## **Report on Consultation**

### **Creag Dhubh to Inveraray 275 kV Overhead Line**

**Reference: LT000194**

**September 2021**

Title: LT194 Inveraray to Creag Dhubh 275 kV Overhead Line  
Figure2: Route Options

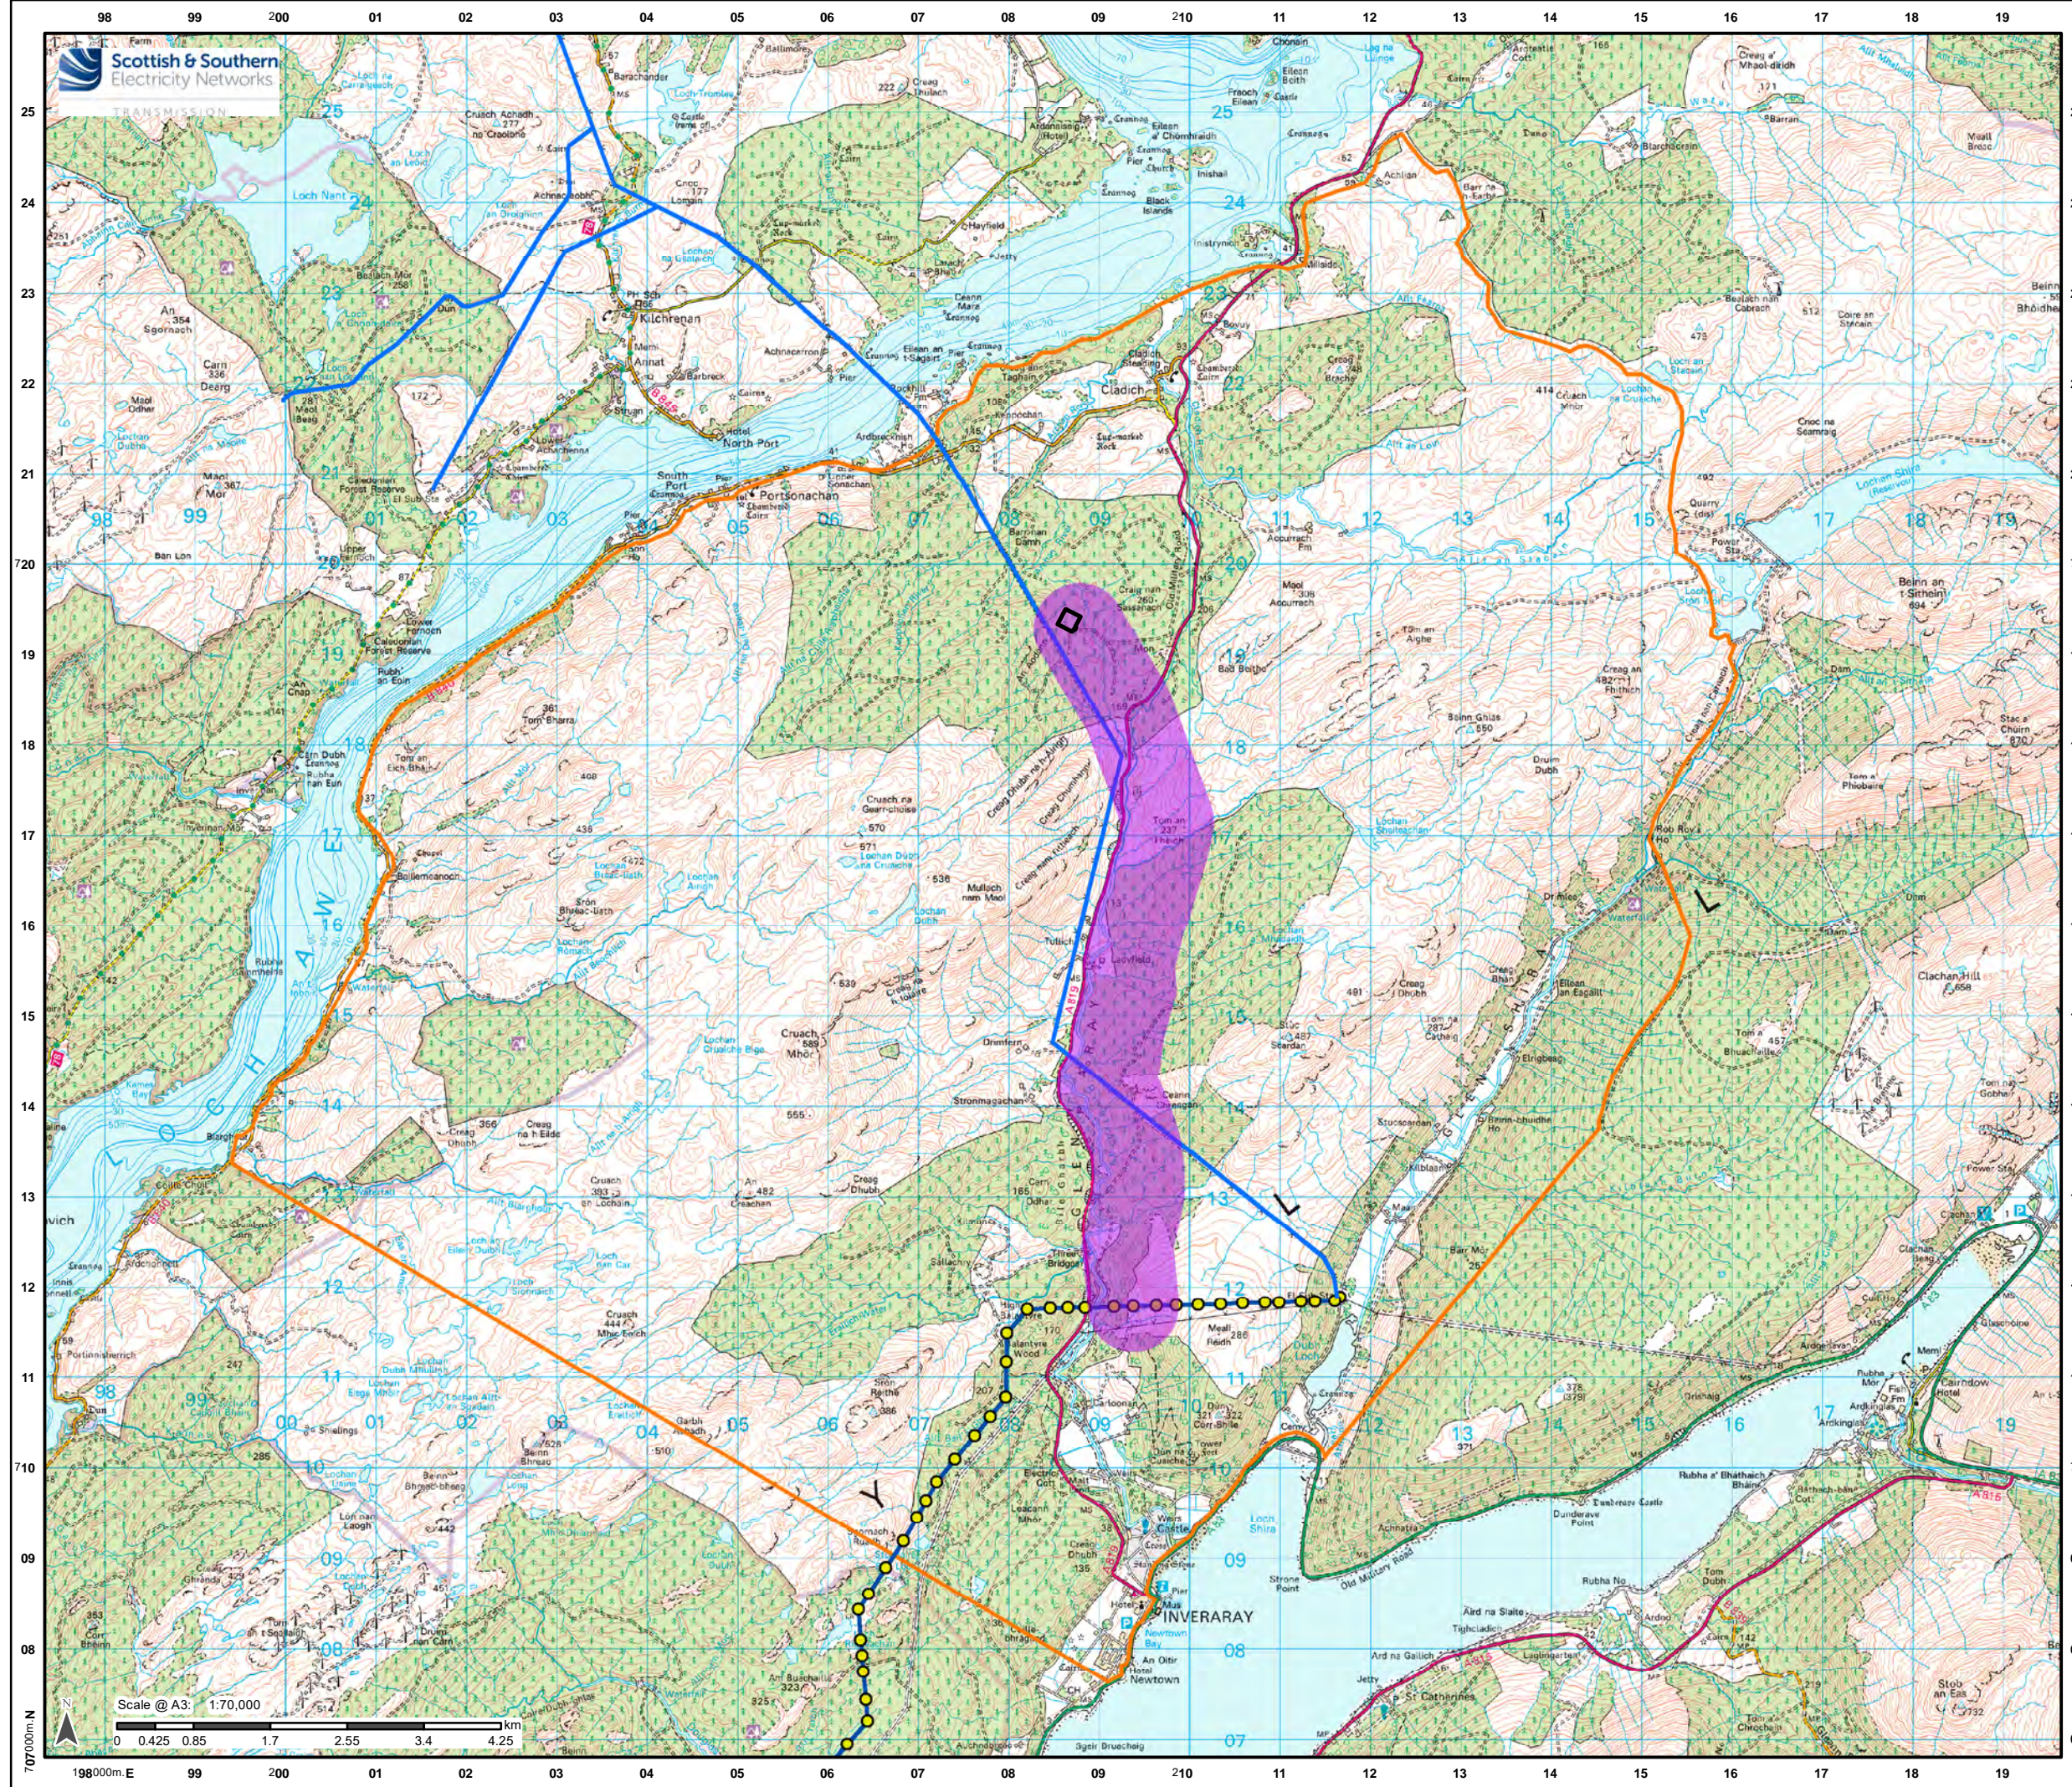
Having considered the various route options and the preferred route option proposed, the Planning Authority is in general agreement that the proposed option D/E would appear to minimise visual impact upon the landscape whilst addressing other restrictions as set out in the RAG analysis matrix. The greater loss of woodland is unfortunate, and potential consequences and mitigation in respect of protected species will have to be carefully addressed. However, it is accepted that replanting strategies can be brought forward to mitigate this as has been the case in other recent S37 proposals.
